TENANT IMPROVEMENT PLAN CHECK COMMENTS

PLAN CHECK NO:	10174233	
PROJECT ADDRESS:	1400 S Village Way	
PLAN CHECK ENGINEER:	Ahangian, Kathy	TEL: 714 647-5812
		FAX: 714 647-5897
TYPE OF CONSTRUCTION:	III B, SPK	
OCCUPANCY CLASSIFICATION(S):	M, S1	
PLAN CHECK DATES:		REMARKS/RECHECK ITEMS:
APPLICATION	1/26/2012	
INITIAL REVIEW	2/4/2012	
EXPIRATION	7/24/2012	
RECHECKS:	1. 2-27-2012	PROJECT APPLICANT CONTACT PERSON:
	2.	Bob Pinault
	3.	TEL: (714)632-9441
VALUATION:	\$25,000.00	FAX:
FLOOD ZONE:	X-0602320277J	EMAIL: bob@rdpinaultcompany.com

BUILDING "H" TENANT IMPROVEMENT FOR Habitat for Humanity

A3.2

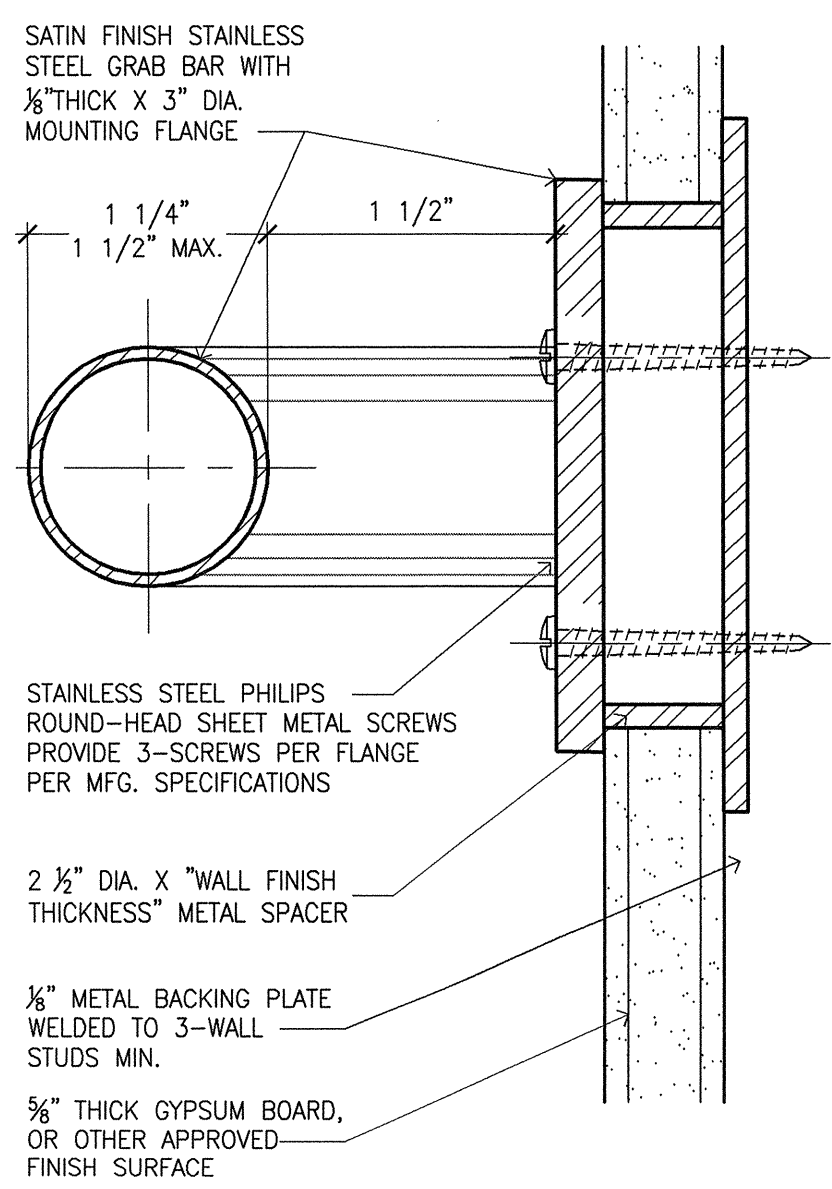
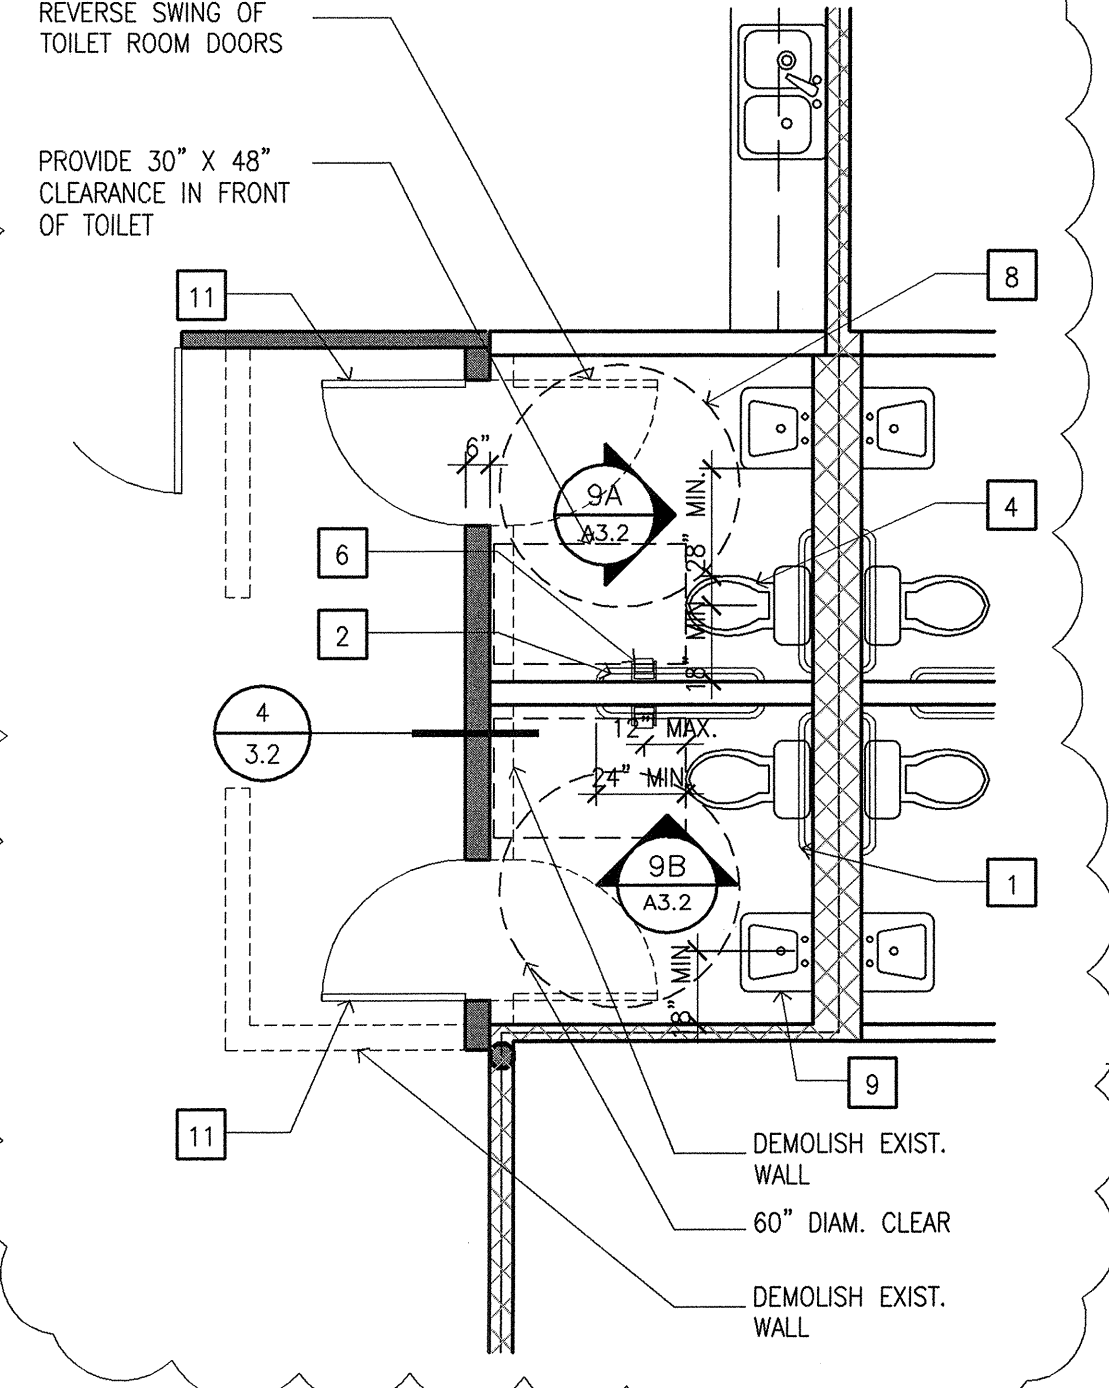
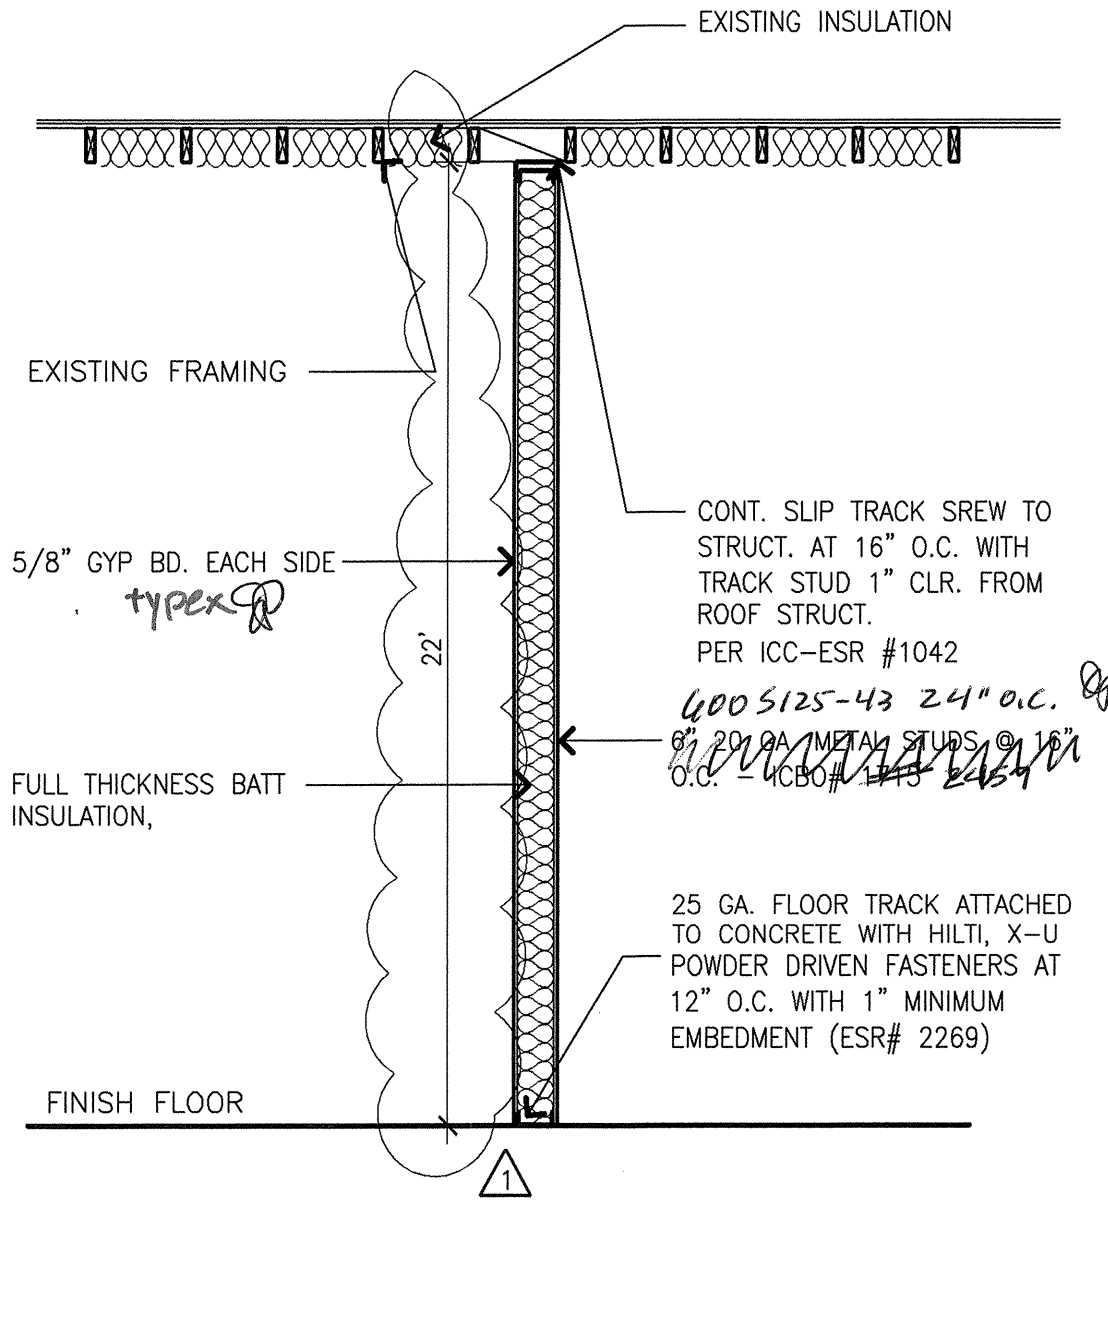
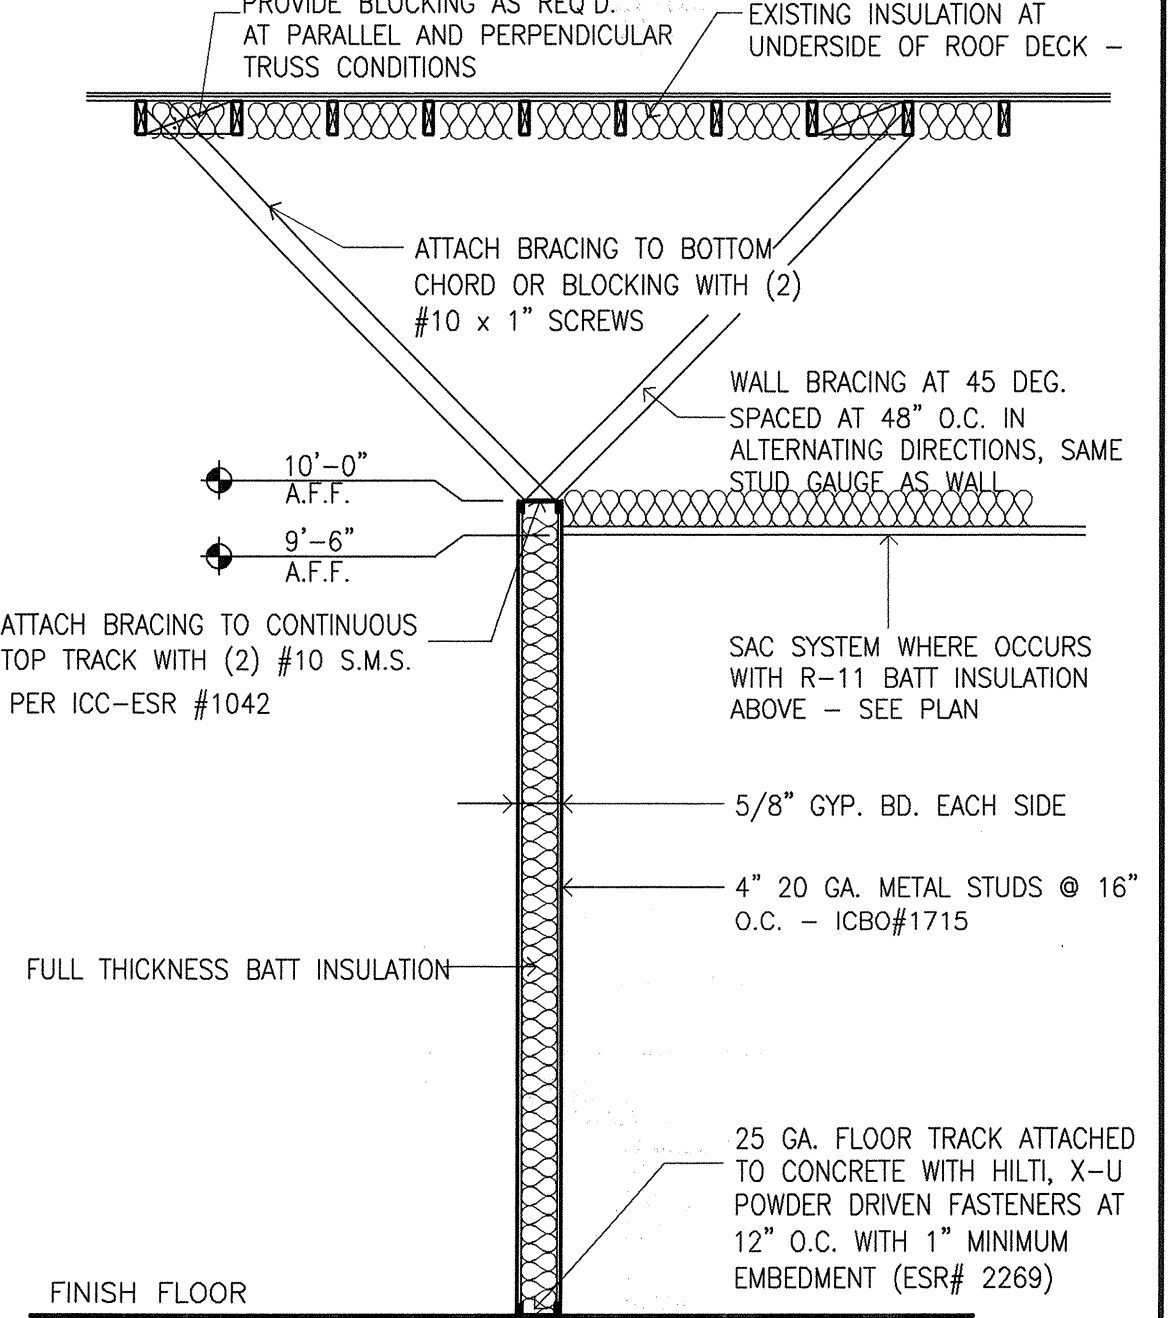
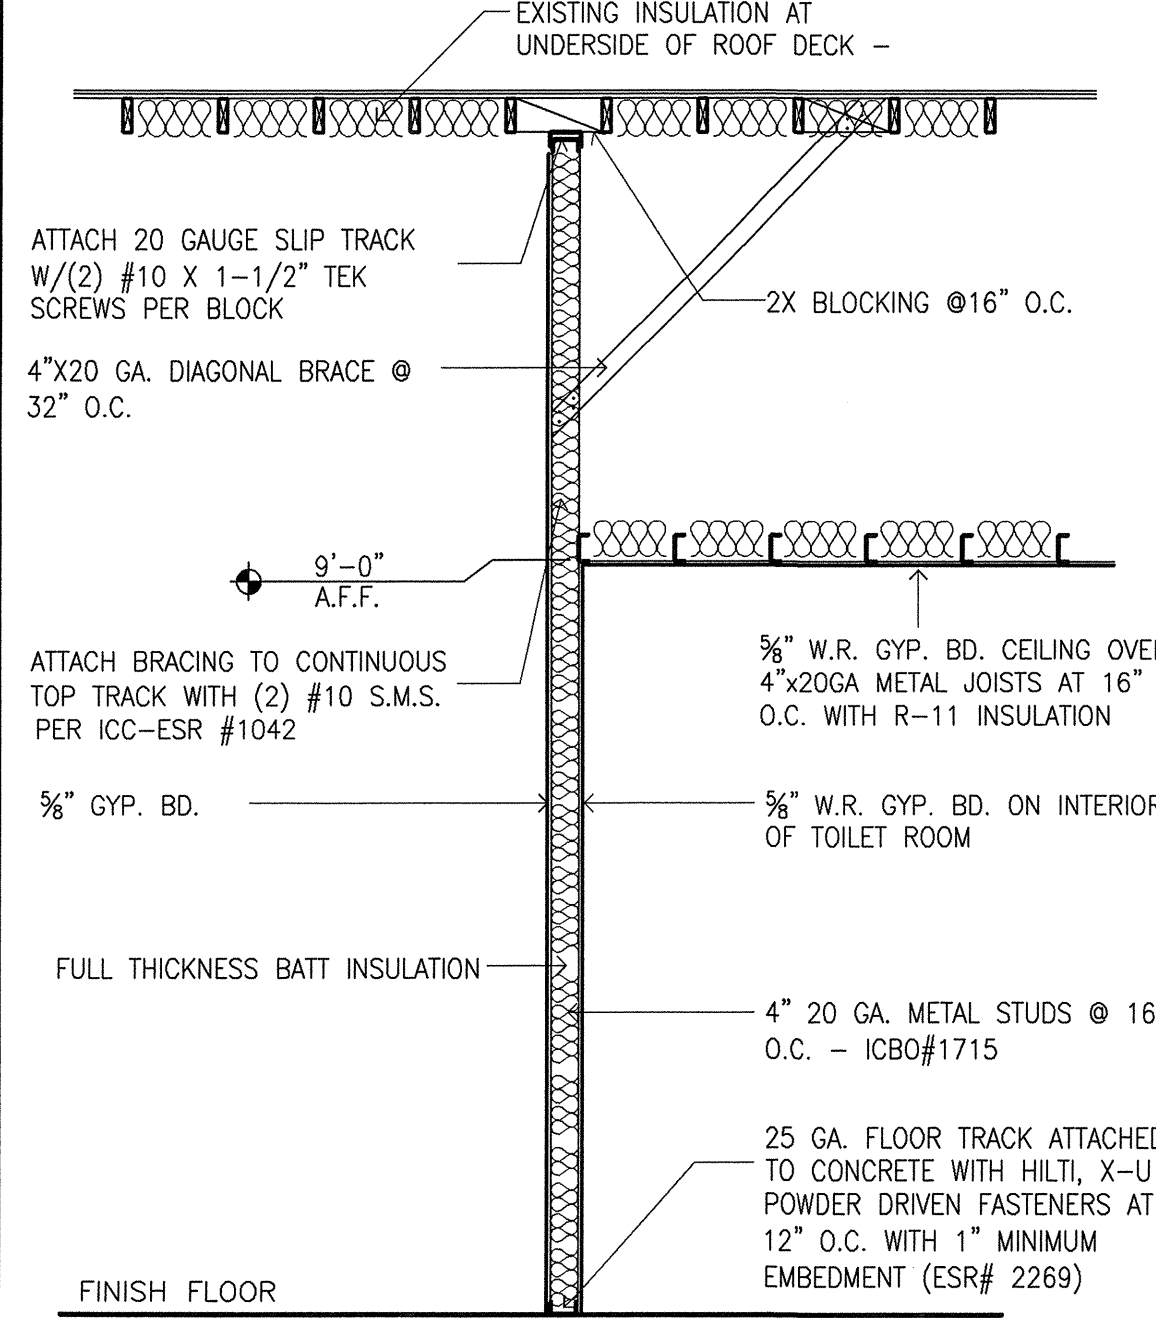
~~17. Show height of the demising wall on detail 2/ A-3.2.~~

Type X. Dry wall.
